PACKARD

Service Counselor

VOL. 23, NO. 3

MARCH 1, 1949

Steam on Windshields and Windows

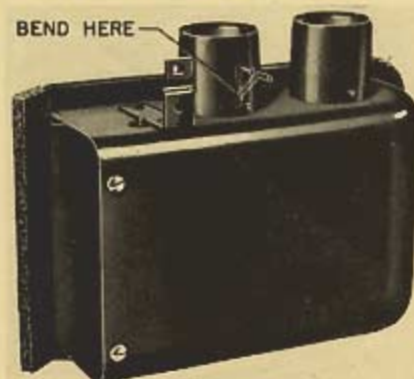
When steam emerges from the heater or defroster outlets in a 22nd Series heater equipped vehicle, the trouble usually may be traced to a leaking heater core or to an accumulation of water in the bottom of the blower housing.

Core leaks, in most cases, can be eliminated by closing the hole with solder. In the event that water has accumulated in the blower housing, the blower assembly should be removed and two $\frac{1}{8}$ -in holes drilled at the lowest point of the housing and the inlet duct as shown in the accompanying illustration. This will provide an escape for any water which may find its way into the housing.

These holes should be drilled and not punched. Punching the holes will upset the metal on the inside, thereby forming a dam around the hole.

Engine Replacement

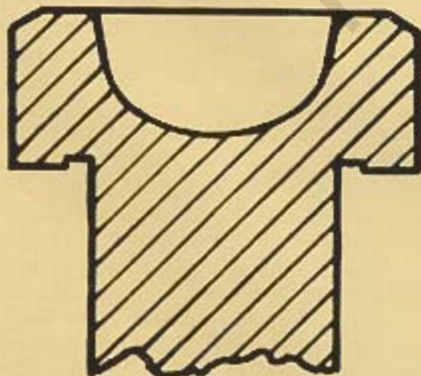
In these kits, a driveshaft is not furnished to accommodate the movement of the engine $\frac{3}{4}$ of an inch toward the rear of the car.

You may now secure from the Henney Motor Company, a front universal joint shaft, $\frac{3}{4}$ of an inch shorter than the standard shaft, to be used with this engine replacement. When this shaft is used the position of the midship bearing remains unchanged.
